REPORT TO THE CALGARY PLANNING COMMISSION

DEVELOPMENT PERMIT	ITEM NO: 04	
	CPC DATE:	2012 May 10
	DP NO:	DP2008-3576

PROPOSAL: New: Offices, Restaurant - Licensed, Restaurant - Food Service and Retail Store	
APPLICANT: Dialog Design	OWNER: Brookfield Properties LTD
MUNICIPAL ADDRESS: 605 – 1 Street SW	LEGAL DESCRIPTION: Plan A, Lots 9 to 20, Block 30
EXISTING LAND USE DISTRICT(S): CM-2 Downtown Business District	
AREA OF SITE: 0.71 ha ± (1.76 ac ±)	
CURRENT DEVELOPMENT: Mid-Rise commercial buildings – retail and office

DRAWING TITLE:
**PODIUM SECTION &
VEGETATED ROOF
DETAIL**
SCALE: 1:200

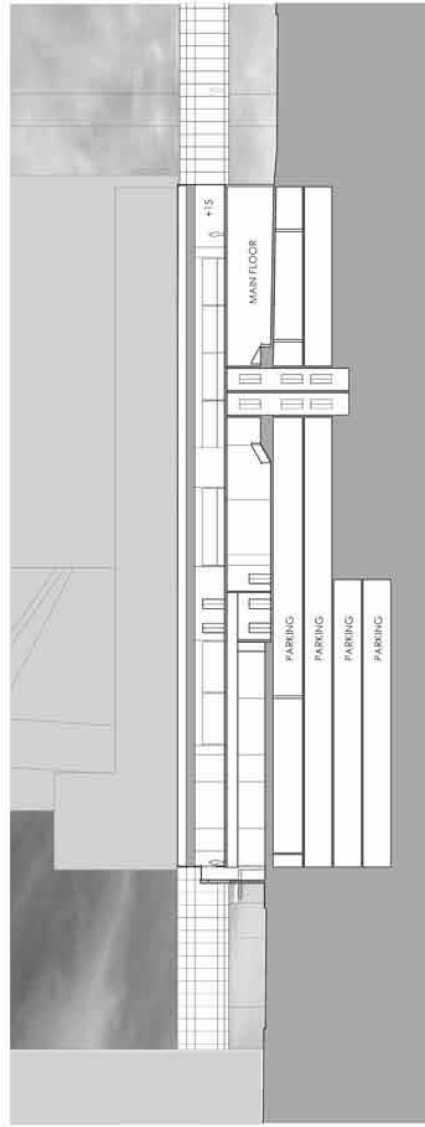
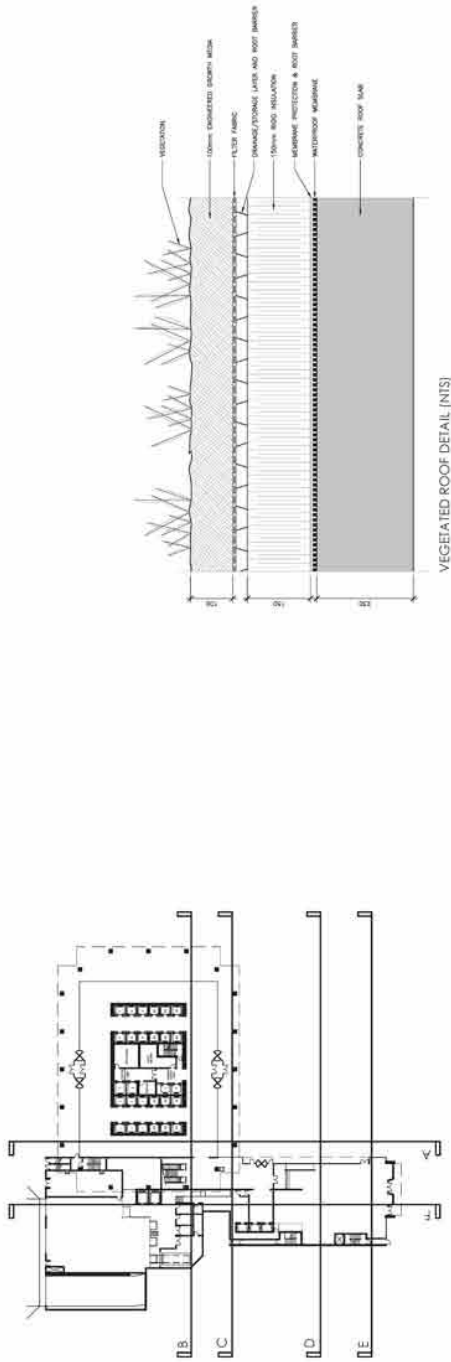
<p>The Panel commends the Applicant for the incorporation of a green roof. However details of location and extent were not apparent in the drawings,</p>	<p>Acknowledged, details provided.</p>
<p>The applicant committed to high quality granite surfacing of the entire plaza area and the Panel would like to ensure that this is carried forward to the final design.</p>	<p>Acknowledged.</p>
<p>The Panel recommends that the Applicant explore the opportunity for a permanent exterior public art piece within the plaza.</p>	<p>Acknowledged this is part of the bonus package.</p>
